Village of Mukwonago
Notice of Meeting and Agenda

PLAN COMMISSION MEETING
Tuesday, May 11, 2021

- 5.1 Public Hearing on a request to consider an Amendment to a Planned Unit Development for a 20-Unit addition onto structure Birchrock Properties LLC, applicant; 210 McDivitt Ln; Parcel MUKV 2012-215-002.
[Public Hearing Notice PC -CU - Birchrock -210 McDivitt - MUKV2012215002 \(2\).pdf](#)
- 5.2 Public Hearing to consider a Conditional Use application for a drive-through facility, with a permitted or conditional use Espresso Love, applicant; 301 Main St; Parcel MUKV 1976-128.
[Public Hearing Notice PC -CU- Espresso Love - 301 Main Street - MUKV1976128.pdf](#)

SITE PLAN AND ARCHITECTURAL REVIEW AND CONDITIONAL USE PERMIT

SHEET TITLE:
EROSION CONTROL
PLAN

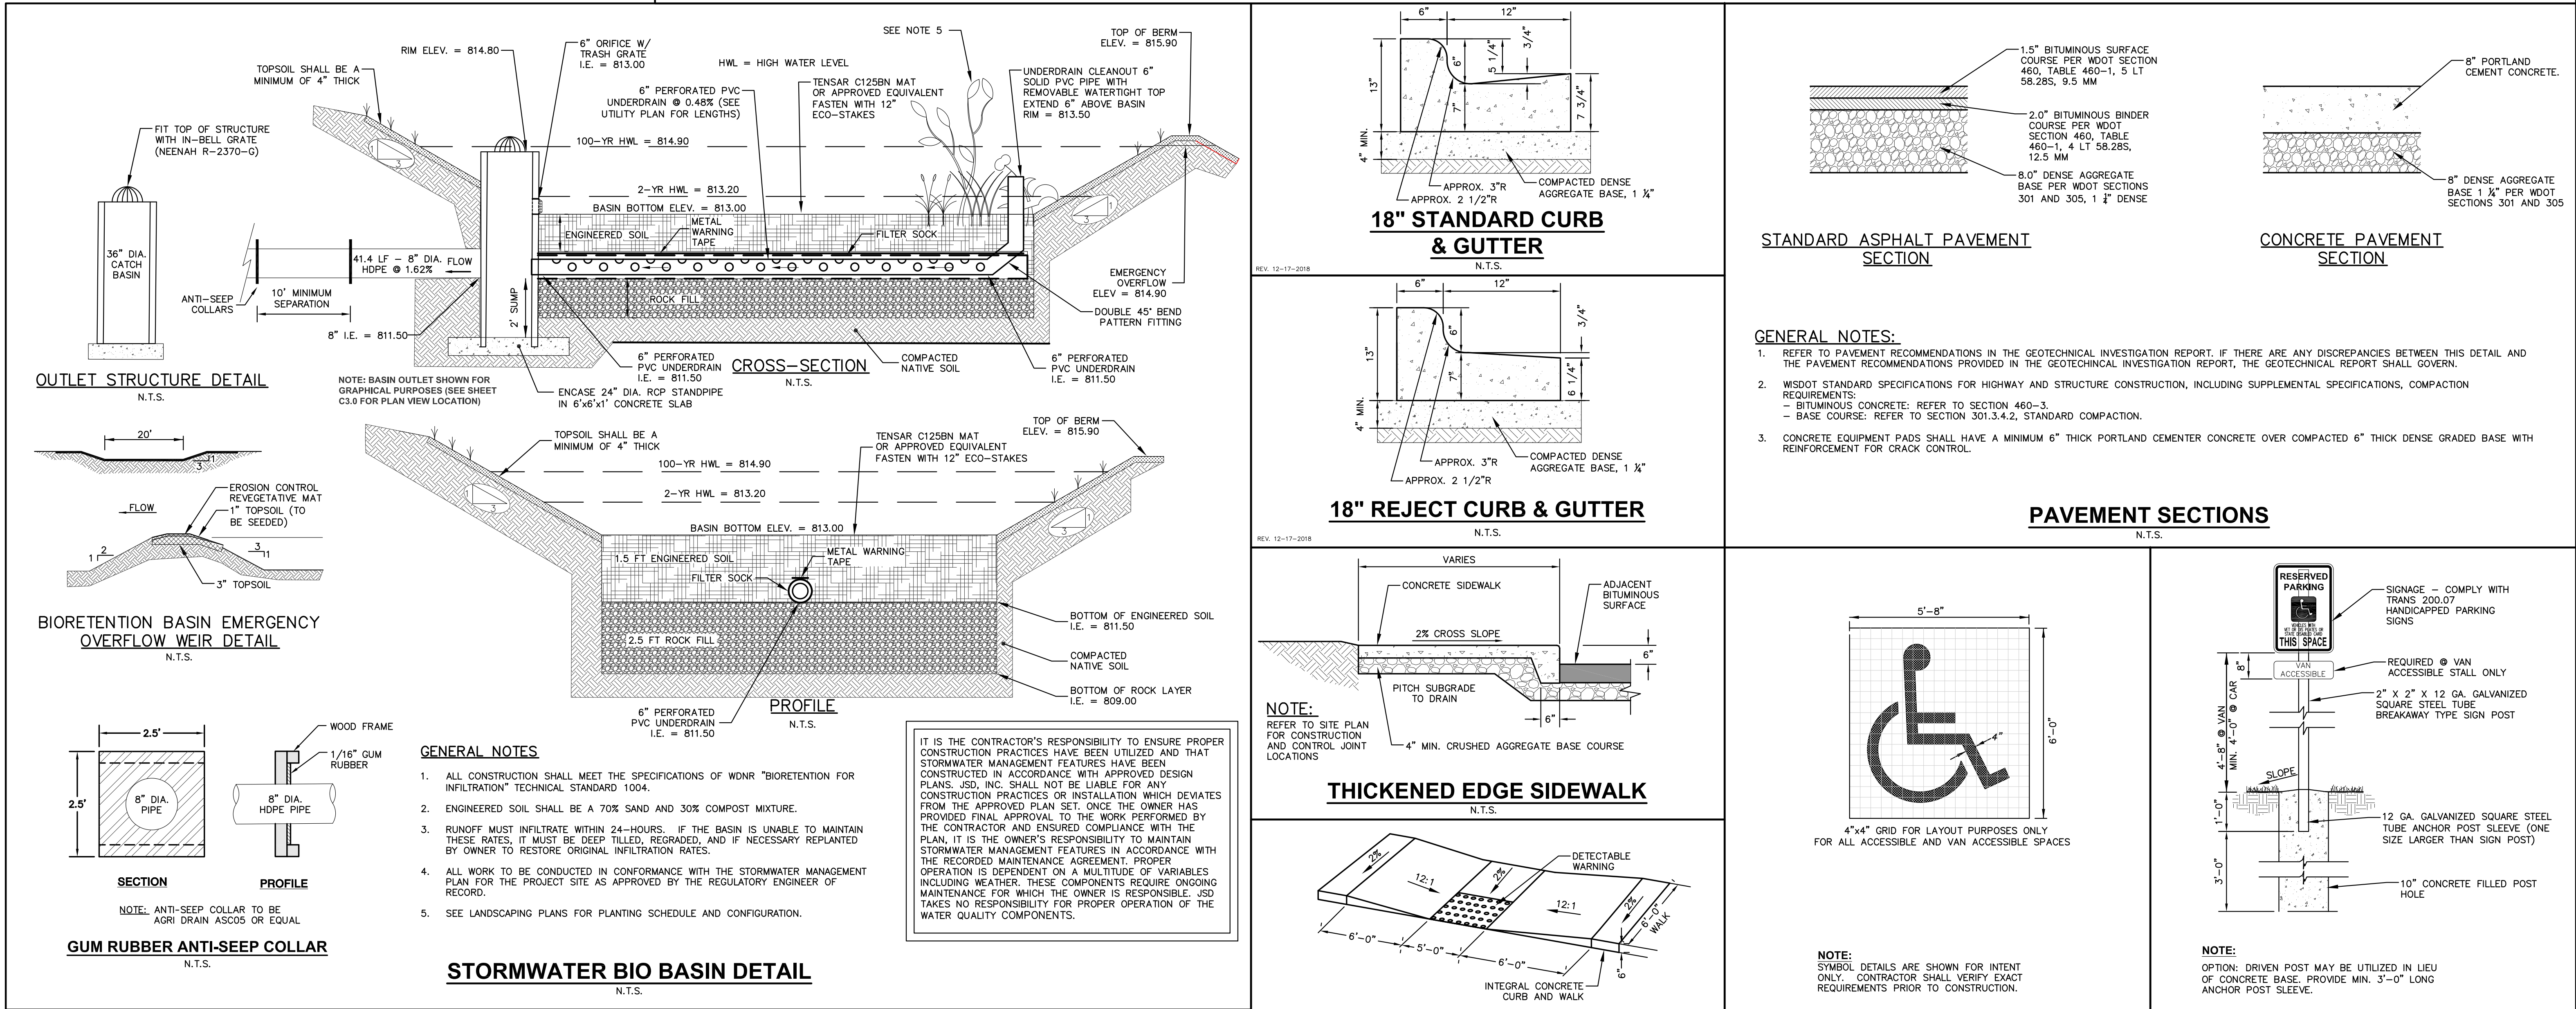
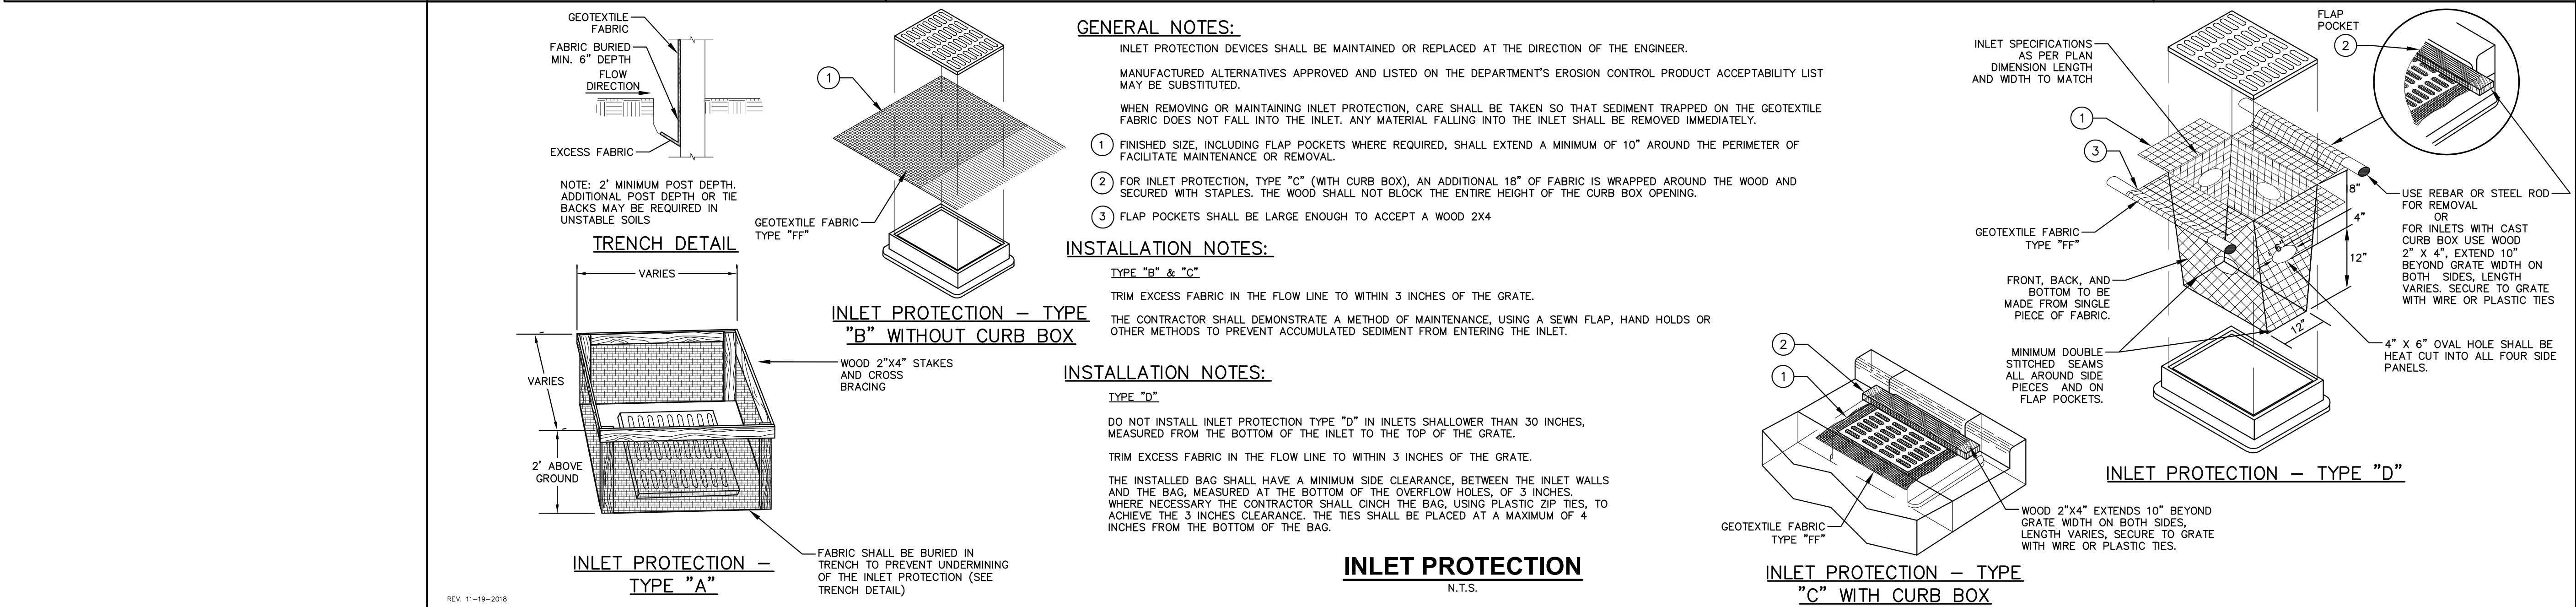
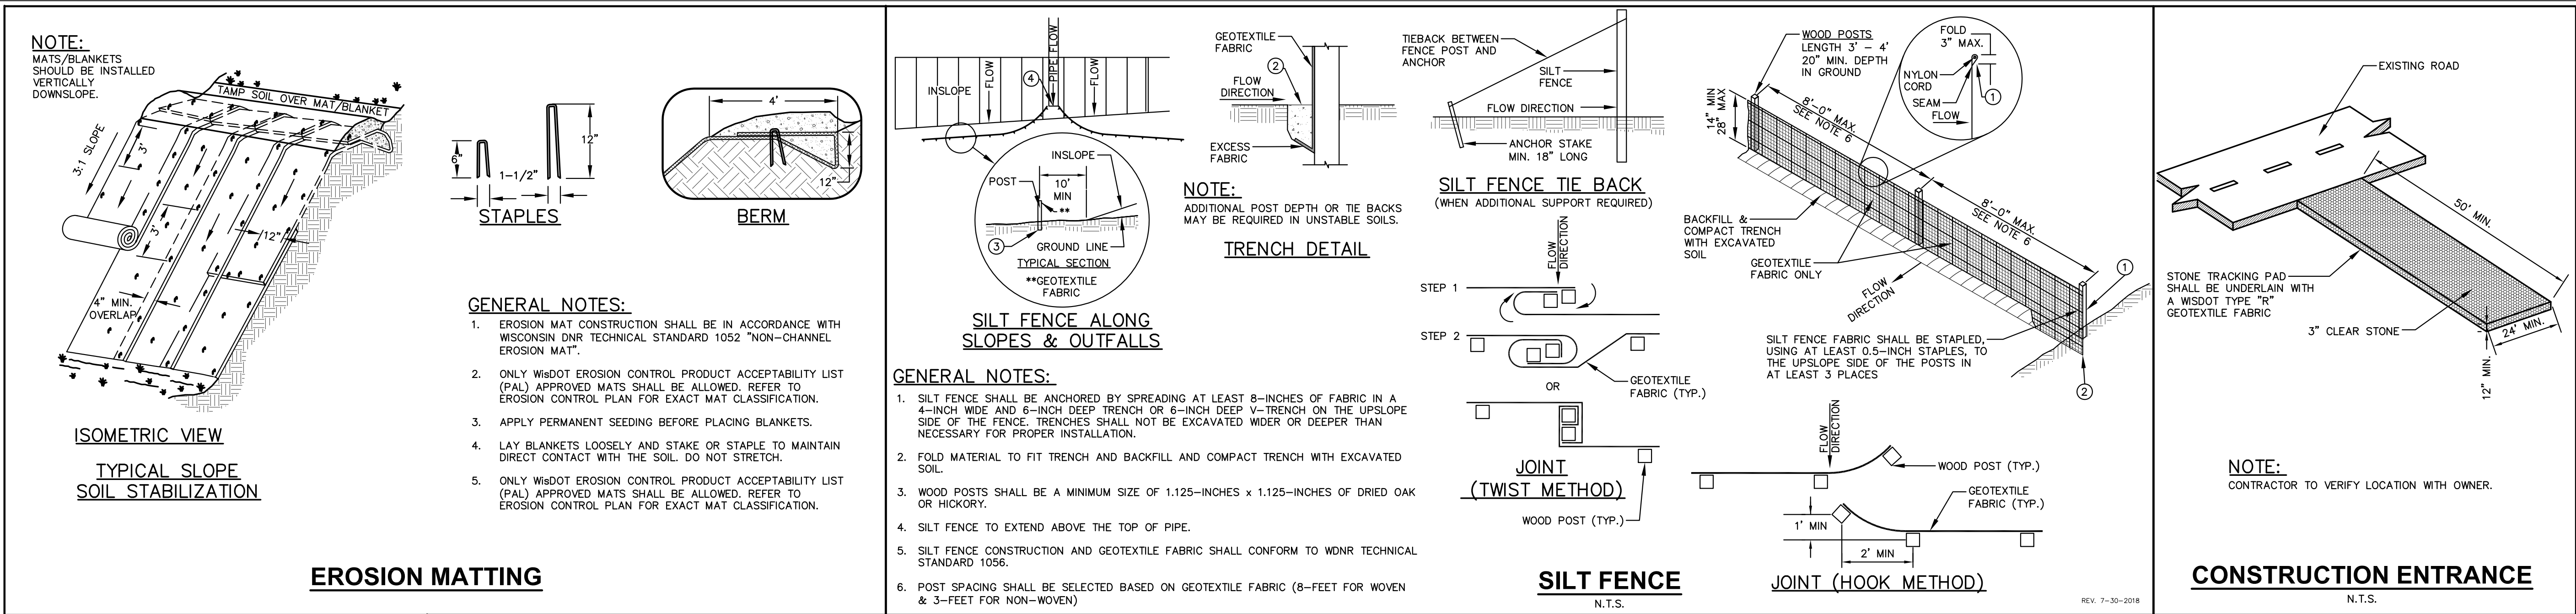
5. Sheet C4.0 – The two storm inlets within Mukwonago Drive, just north of the proposed tracking pad should have inlet protection.
6. Sheet C4.0 – The construction of the building should be added into the "Construction Sequencing" notes.

7. Sheet C4.0 – The final note of the “Construction Sequencing” states that the contractor can modify the sequence after Item No. 1 as needed as long as erosion controls are maintained. The sediment basin is one of those erosion control measures that must be maintained, but is not listed to be constructed in the sequence until Item No. 4. The final note or the sequence should be modified such that it is clear that the sediment basin should be constructed prior to site grading and building construction and that that part of the sequence may not be modified. The final note should also state that modifications to the construction sequence require submittal to and approval by the Village of Mukwonago.

8. Sheet C4.0 – The outfall structures should have ditch checks on the downstream side as added protection prior to discharging into the wetland areas.

9. Sheet C4.0 – Type of inlet protection should be called out on each inlet such that it is evident which type of protection is intended to be installed at each location.
